SLR Project No.: 402.v08525.00024

RE: Planning Application 25/00228/FUL Land North of Cut Lane, Kirkby

SLR has received the following feedback from the Local Authority(LA). The LA's comments are highlighted in ***italic bold***, with SLR's response below.

Figure Error! No text of specified style in document.-1 Comparison Between the Existing Internal Ambient Noise Level with a Partially Open Window

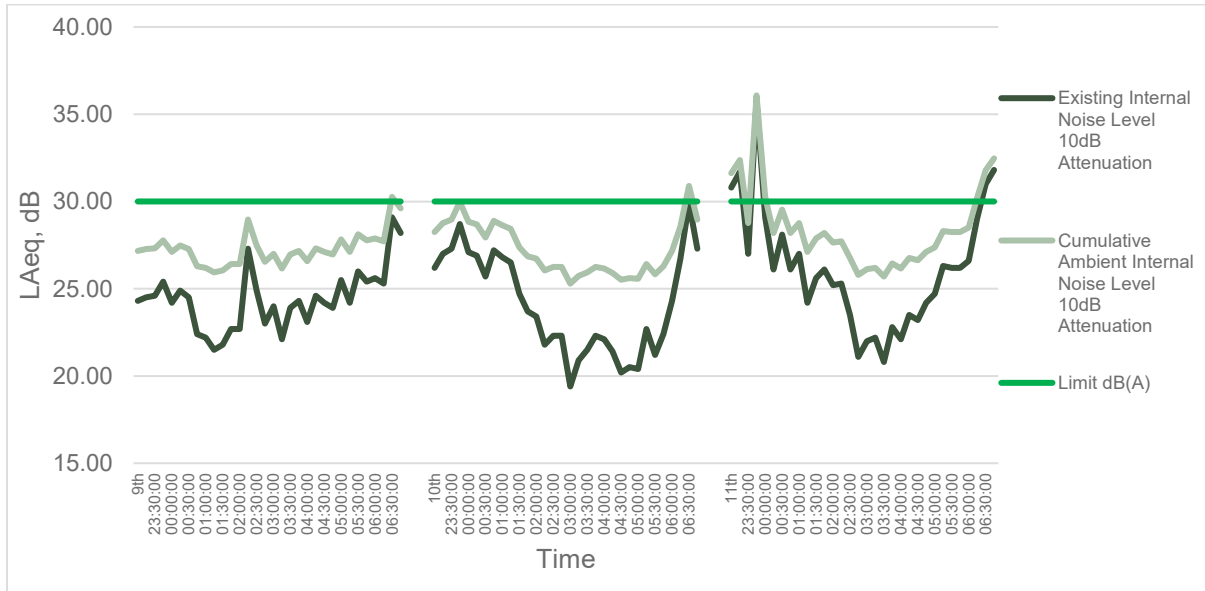
8. ***From the assessment the background sound levels at location 2 was typically 31dB with open windows the noise level within the properties will be significantly lower, the noise from the battery energy storage will have a great sound level difference than is proposed and will clearly be audible and have an adverse impact on the existing residents.***

Please refer to Figure 5-4 in the Report. This Figure is copied below.

The graph is relevant to the context discussion at Sandy Brow Cottages and Red Cut Lane.

Accounting for a partially open window reducing external noise by 10dBA (both existing noise and the specific noise from the Site), the internal total internal $L_{Aeq,T}$ noise level at night will meet the WHO limit of 30dBA for most of the time. Where the limit is exceeded, the exceedance is not caused by the operation of the BESS Site (as evidenced by the existing internal noise level also exceeding the 30dB line).

Whilst not shown on the graph the change in noise level between the existing and cumulative scenarios is less than 3dBA for 67 of the 96 comparable data sets (difference ranged between 0dBA and 6dBA). This is relevant as in accordance with the IEMA Guidelines¹ paragraph 2.7, for a sound level increase to be perceptible, the change in sound needs to be 3dB(A).

Where the difference was greater than 3dBA the time period was focussed on the early hours of the morning, thus not encroaching on the period where residents would most likely be looking to fall asleep or would be waking up. This is acknowledged in BS4142 where at Section 8-1 it states:

Figure Error! No text of specified style in document.-2 Comparison of Measured External Residual Sound Level with Predicted Specific Sound Level

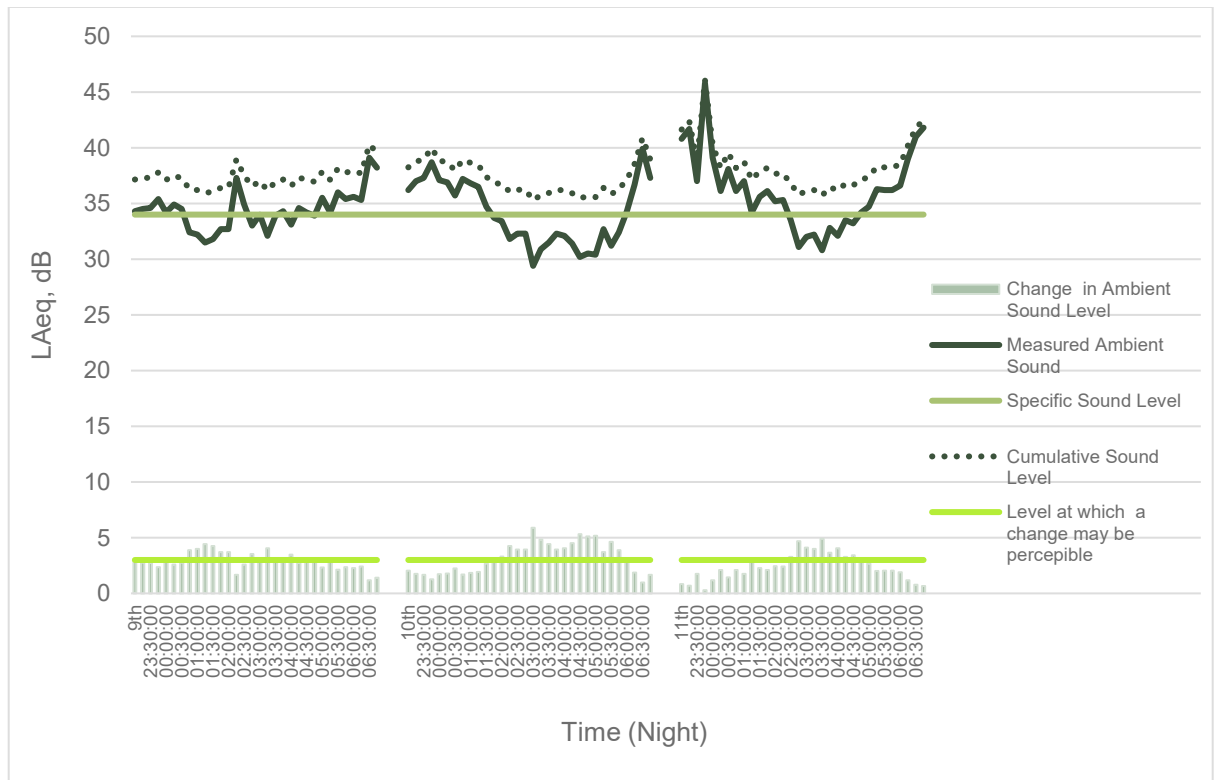
9. ***The report states that the site will elevate the total ambient noise level and may not be perceptible to residents, the noise will be different to what the residents are currently used to and therefore will be more evident particularly during the nighttime periods.***

The change in the ambient sound level is illustrated in Figure 5-3 of the Report which is copied below.

As stated previously, the change is less than 3dBA for 67 of the 96 comparable data sets (difference ranged between 0dBA and 6dBA). This is relevant as in accordance with the IEMA Guidelines² paragraph 2.7, for a sound level increase to be perceptible, the change in sound needs to be 3dB(A).

Where the difference was greater than 3dBA the time period was focussed on the early hours of the morning, thus not encroaching on the period where residents would most likely be looking to fall asleep or would be waking up. This is acknowledged in BS4142 where at Section 8-1 it states:

The BESS will be a new source of sound, but as demonstrated in the SLR Report and this letter, when considered in context, the impact is acceptable.
